HEARING DATE: May 9, 2023

TO: Mayor & City Council

FROM: Sonya Allen, Associate Planner
208-884-5533

SUBJECT: Modern Craftsman Franklin AZ, CUP,
MDA, PP, PS H-2022-0079
(aka Colorado Ridge)

B. Preliminary Plat (dated: 10/20/22)

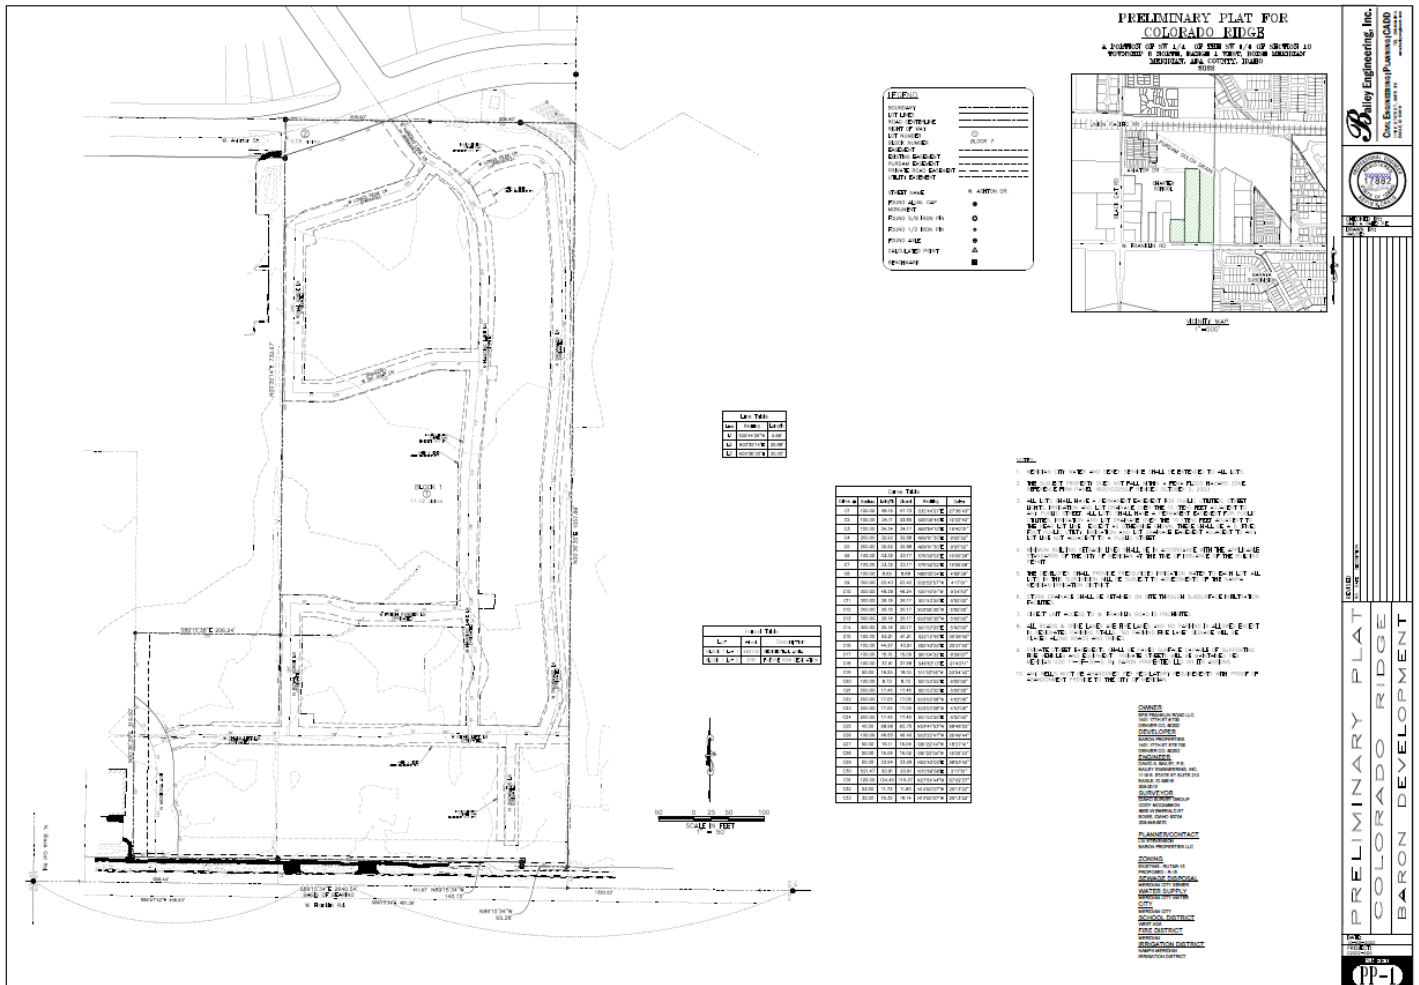
Access: Access is proposed via the extension of W. Aviator St., a collector street, which is planned to cross the northwest corner of the site and extend to the northeast through Aviator and Newkirk Subdivisions. **If Aviator St. hasn't been constructed with Aviator Subdivision, ACHD is requiring the on-site and an off-site portion to be constructed with this subdivision. The street shall be designed consistent with Street Section C (major collector street) in the Ten Mile Interchange Specific Area Plan, unless an alternative street section is approved by ACHD (see pgs. 3-20, 3-22 and 3-23).**

Private streets are proposed for internal access within the development and are required to comply with the standards listed in UDC [11-3F-4](#). **The Director approved the private streets with the condition they're constructed on a lot in the subdivision rather than an easement since the property is being subdivided in accord with UDC 11-3F-4A.1; the plat should be revised accordingly. Where the private street connects to a public street (i.e. W. Aviator St.), the connection shall be approved by ACHD. The private streets should be constructed in accord with the standards listed in UDC 11-3F-4B.2.**

D. Site Plan (dated: 10/20/2022)

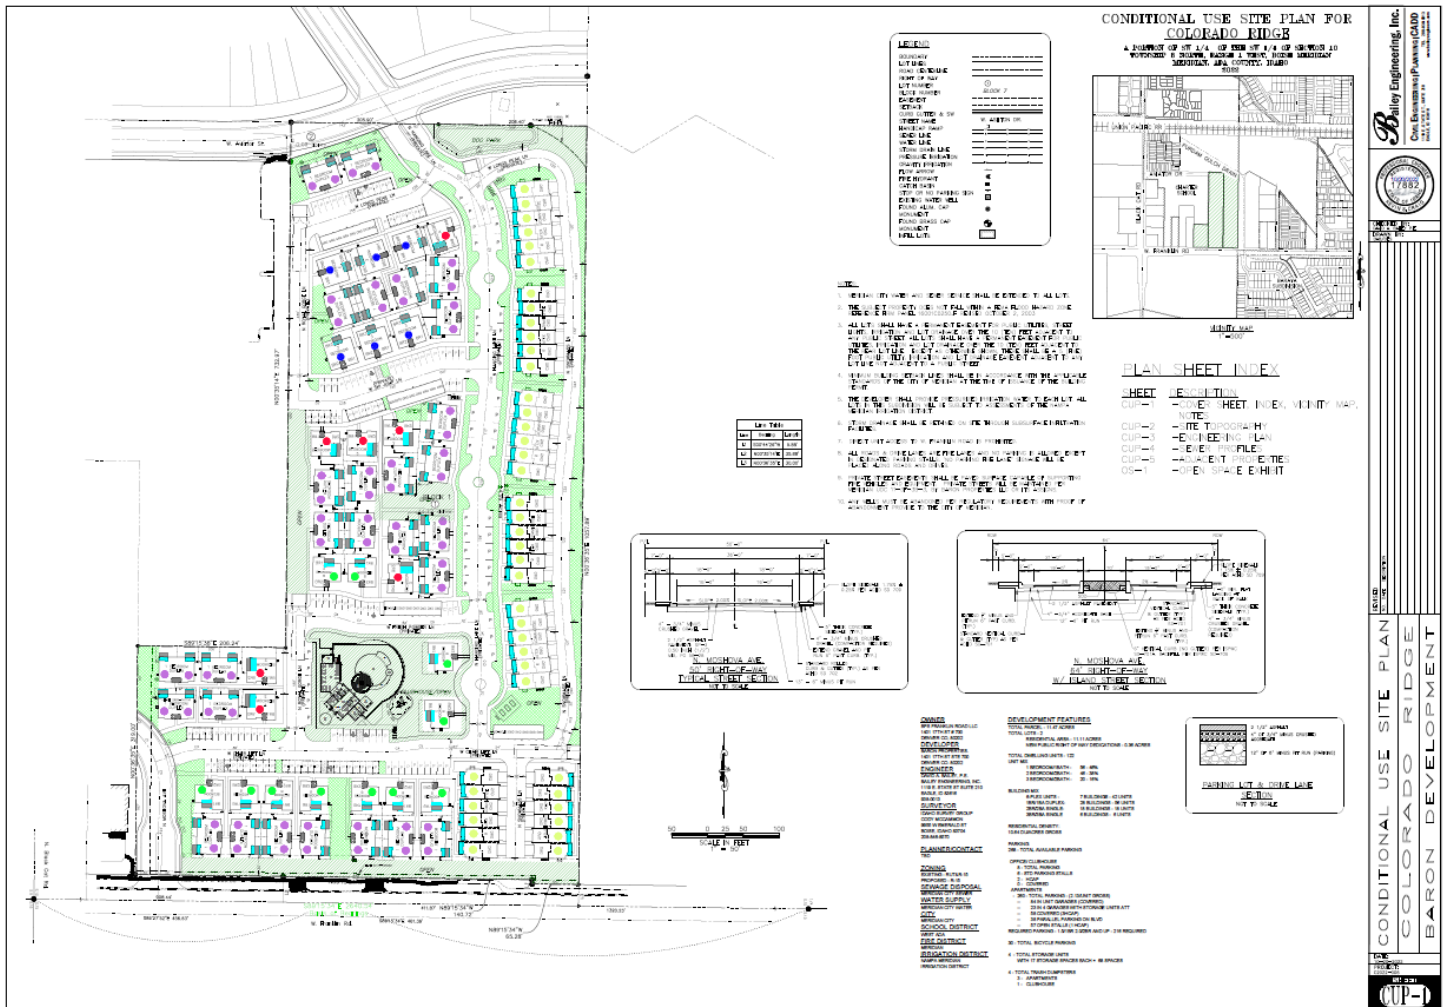
- a. Remove the street sections for N. Moshova Ave. and depict a drive aisle instead of a public street on the plan. The drive aisle shall be located along the west property to ensure the parcel to the west can utilize the access. Depict a sidewalk along the drive aisle for pedestrian connectivity and safety.

- h. The drive aisle via W. Franklin Rd. shall be located along the west property line in order to provide a shared access to the property to the west (Parcel #S1210336377).

- j. Depict the location of the property management office, maintenance storage area, central mailbox location (including provisions for parcel mail, that provide safe pedestrian and/or vehicular access), and a directory and map of the development at an entrance or convenient location for those entering the development as set forth in UDC [11-4-3-27B.7](#).

COLORADO RIDGE
MERIDIAN, ID CUP LANDSCAPE PLAN

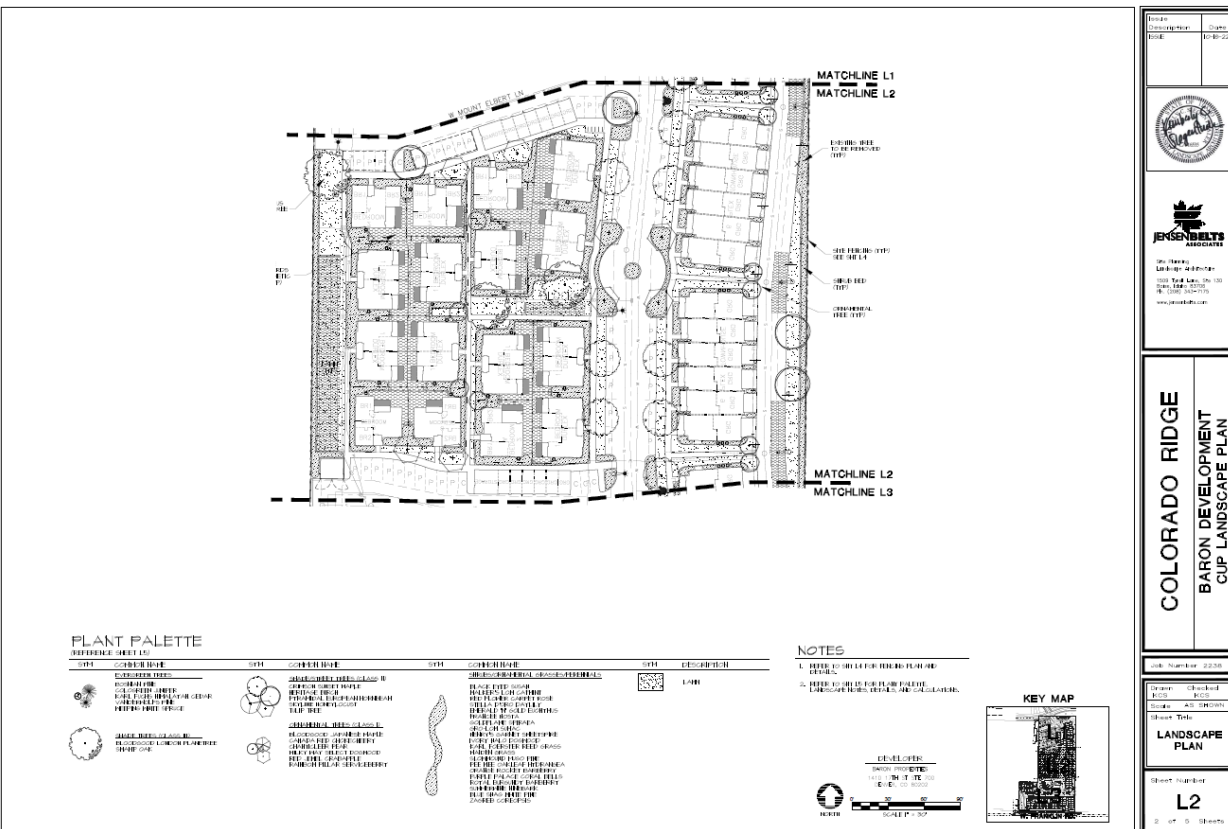
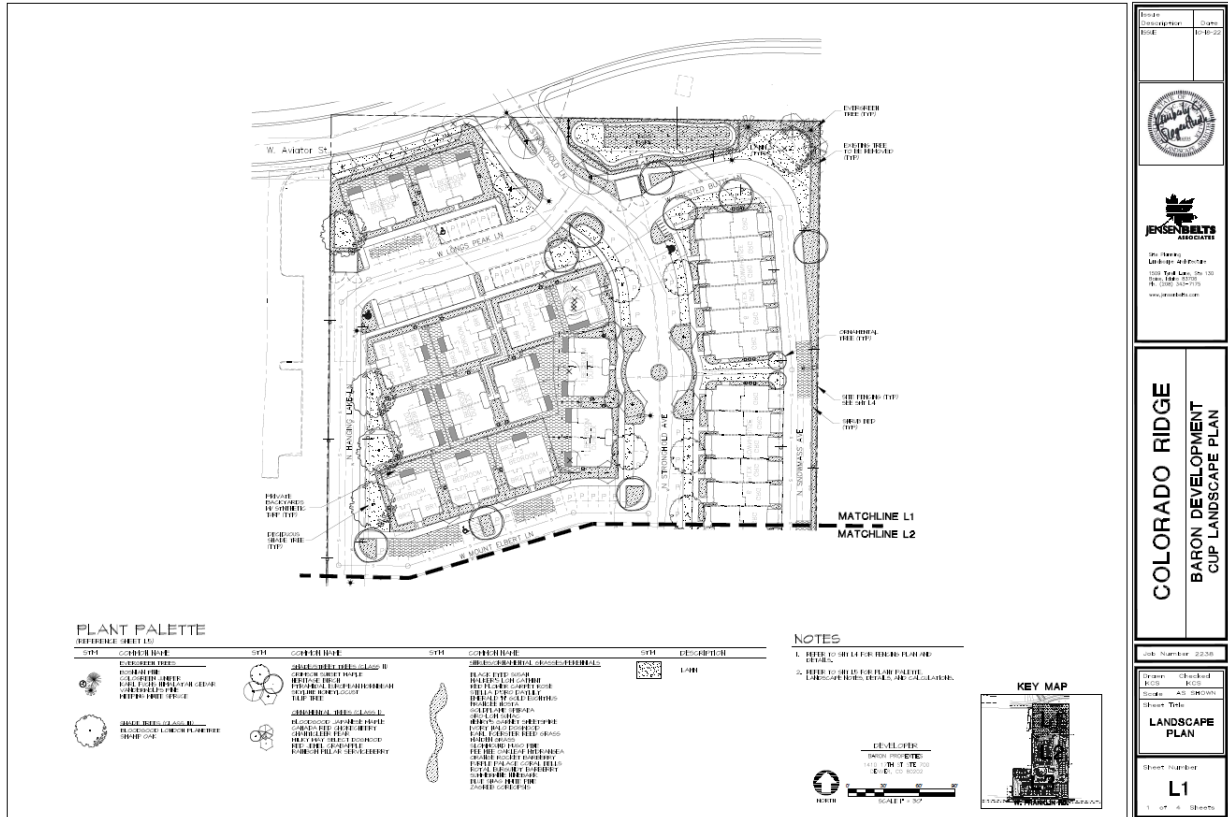
All common open space areas are required to be landscaped with one deciduous shade tree for every 5,000 square feet of area and include a variety of trees, shrubs, lawn or other vegetative groundcover per UDC [11-3G-5B.3](#). **Shrubs should be added to common open space areas and the calculations table on the landscape plan (Sheet L5) should be updated to demonstrate compliance with this standard.**

There are several existing trees on this site that will be removed with development as depicted on the landscape plan. **Mitigation is required to be provided per the standards listed in UDC [11-3B-10C.5](#); calculations demonstrating compliance should be included on the landscape plan submitted with the Certificate of Zoning Compliance and/or final plat application.**

- b. Depict landscaping within the 20-foot wide street buffer along W. Aviator St. in accord with the *updated* standards listed in UDC [11-3B-7C](#). An 8-foot wide parkway is required along the collector street planted with Class II trees and a 6-foot wide detached sidewalk as set forth in the TMISAP (Street Section C). Include the linear feet of buffer with the number of required vs. provided trees in the Landscape Calculations table on Sheet L5 that demonstrates compliance with UDC standards.

- d. Change the fencing type along the east boundary of the site adjacent to the Purdam Gulch Drain to 6-foot tall wrought iron in accord with UDC [11-3A-6C.3](#). *Fencing should not encroach within the easement at the northeast corner of the site without a License Agreement with NMID.*

- f. Provide a 4-foot tall berm (or constructed barrier) within the street buffer along W. Franklin Rd. as proposed in accord with UDC [11-4-3-27C.7](#). Provide a break in the berm and extend the pedestrian pathway in the central common area between the 1- and 2-bedroom units to the sidewalk along Franklin Rd.
